**NOTICE OF A REGULAR MEETING
BONDURANT PLANNING AND ZONING COMMISSION
MARCH 24, 2022**

Item No. 6.b.
For Meeting of 3/24/2022
Resolution

TITLE: - RESOLUTION NO. PZ-220324-09: Considering recommended approval of the Edgeland Bondurant Preliminary Plat and Site Plan at Outlot R of the Quail Run Phase 2 Preliminary Plat development area.

TITLE: - RESOLUTION NO. PZ-220324-10: Considering recommended approval of the 1001 23rd Street SW Site Plan

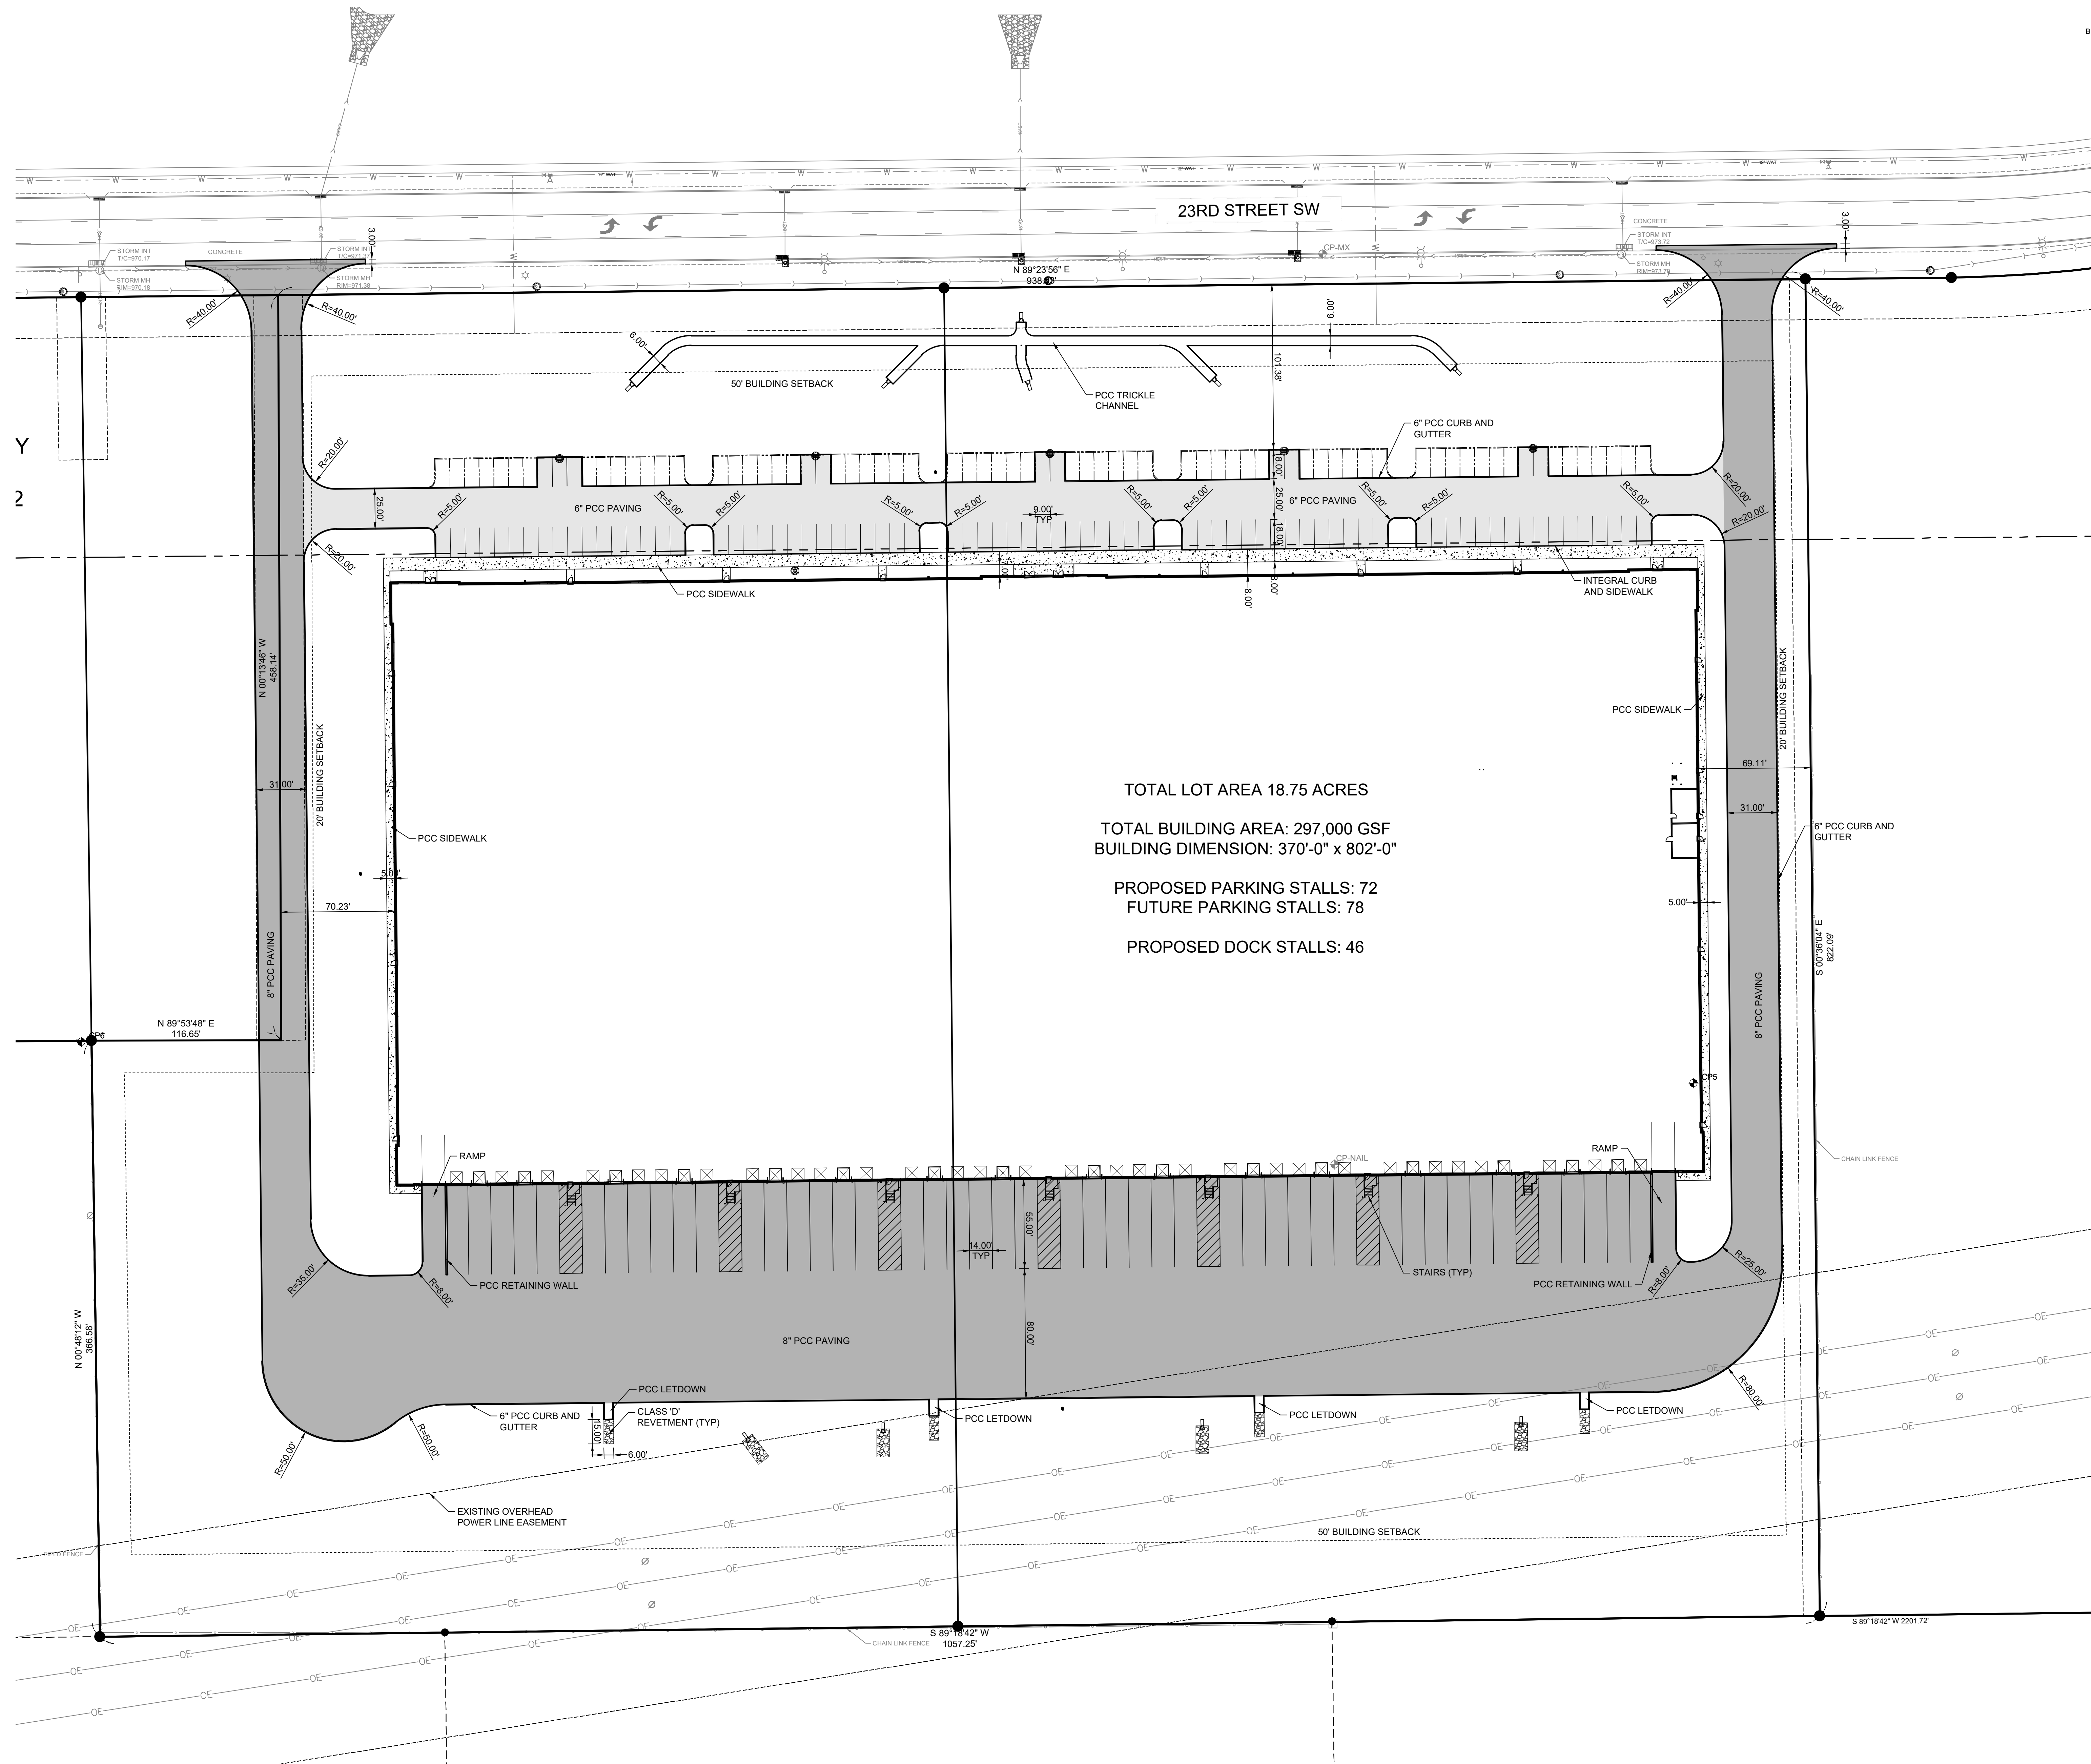
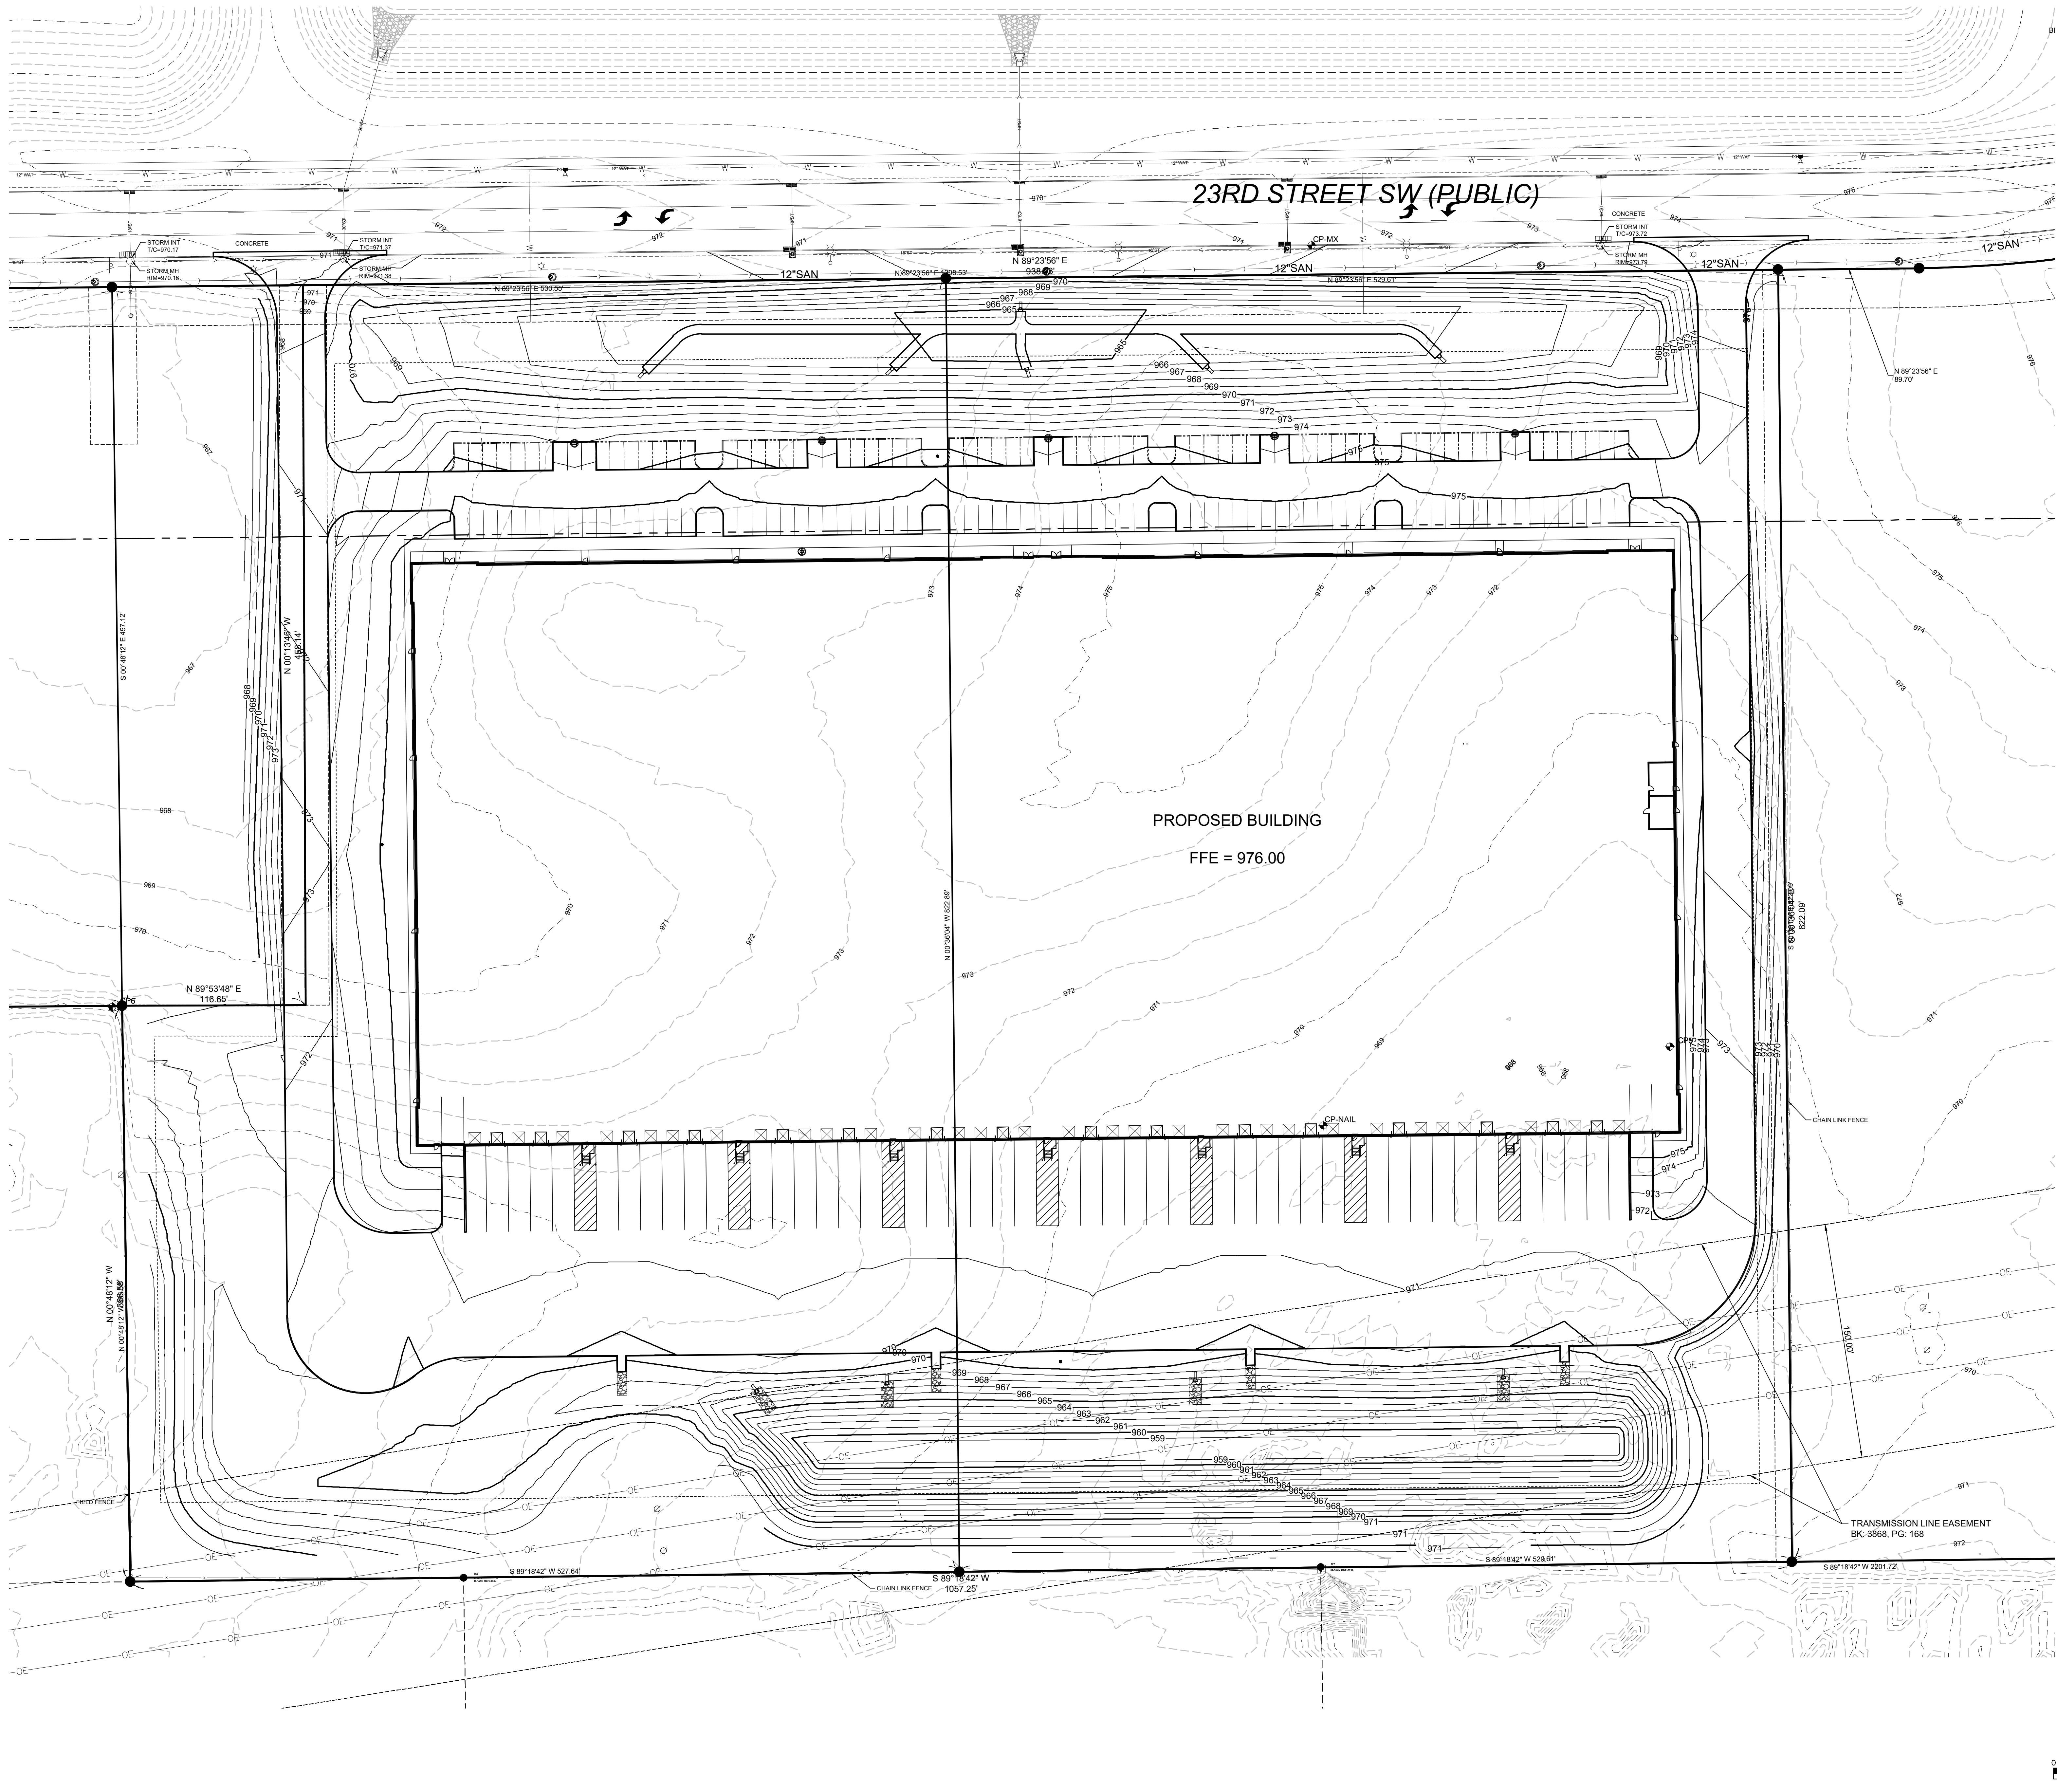
Section 177.09.21 of the Zoning Code requires at least one parking space on the lot per be provided each employee at one time. Currently, 72 parking stalls are proposed, however, the site plan is currently lacking on the number of employees; the attached P&Z recommendation resolution takes this into account.

As currently proposed, a total of 3 handicapped spaces are required for the site. The site plan notes that 5 ADA parking stalls are proposed, however, the locations of these five stalls are not proposed. This has been factored in as part of the attached resolution.

The site plan shows it, but does not label the existing sanitary sewer easement that exists along the north property line.

The plat of survey being considered in Item 6.d shows a 30'x100' access easement at the west driveway. The site plan will need to be updated to show this easement area.

2. That the site plan's employee count information be completed to ensure minimum parking stall count requirements will be met.
3. That approval of this site plan also includes approval of the future potential parking space areas as shown on the plan. If this future parking space area is constructed, the developer must provide updated total impervious surface calculations to the City for stormwater billing purposes.

4. That the site plan be updated to clarify the number and location of the ADA parking spaces proposed.
5. That the landscaping plan be updated to show that at least 21 general trees will be planted within the required minimum front yard setback area.

6. That the site plan be updated to show/label all existing and proposed easements on site.
7. That sidewalks may be required if/when the City determines a logical connection exists, as is allowed per Chapter 136 of the City Code.
